Access Compliance Report Public Rights-of-Way (Pedestrian Signals)

Main Street: **CHIQUITA_CANYON_DR** Cross Street: **ESENCIA_DR** Location: **NW**

ADA ID: **SGRK211124132457** Signal Type: **One Push Button-Non APS** Overall Compliance: **No** Severity Scores: **BTN 1: 35** **BTN 2: N/A** **No BTN: N/A**

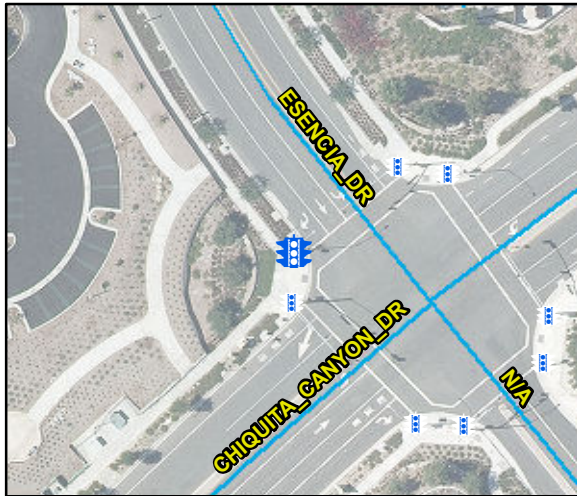
OC Std/PROW: **MUTCD 4e.08, R404.2**

N/A Is Button 1 APS or Non-APS?	NonAPS	N/A Is Button 2 APS or Non-APS?	N/A
N/A B 1 VibroTact Arrow?	N/A	N/A B 2 VibroTact Arrow?	N/A
N/A B 1 VibroTact Parallel to Xing?	N/A	N/A B 2 VibroTact Parallel to Xing?	N/A
N/A B 1 VibroTact Contrast	N/A	N/A B 2 VibroTact Contrast	N/A
No B 1 Pilot Light?	No	N/A B 2 Pilot Light?	N/A
N/A B 1 Pilot Light Illumination?	N/A	N/A B 2 Pilot Light Illumination?	N/A
N/A B 1 Walk Indicator Type	N/A	N/A B 2 Walk Indicator Type	N/A
N/A B 1 Walk Indicator Audible?	N/A	N/A B 2 Walk Indicator Audible?	N/A
N/A B 1 Locator Tone?	N/A	N/A B 2 Locator Tone?	N/A
N/A B 1 Tone Audible Range?	N/A	N/A B 2 Tone Audible Range?	N/A
B 1 Addl APS Features?	No	B 2 Addl APS Features?	N/A
B 1 Addl APS Features Notes	N/A	B 2 Addl APS Features Notes	N/A

Yes	B 1 Diameter (in)	2	N/A	B 2 Diameter (in)	N/A
N/A	B 1 Crossing Direction	NE	N/A	B 2 Crossing Direction	N/A
No	B 1 DistanceTo XWalk (in)	62	N/A	B 2 DistanceTo XWalk (in)	N/A
Yes	B 1 DistanceTo Curb (in)	38	N/A	B 2 DistanceTo Curb (in)	N/A
	Parcel Identification Number	125-222-08			
	Google Street View Link				
	http://www.google.com/maps/@?api=1&map_action=pano&viewpoint=33.54543236,-117.60033458

Possible Solutions: Replace Signal Push Button With APS Button. Remove & Relocate Sign.
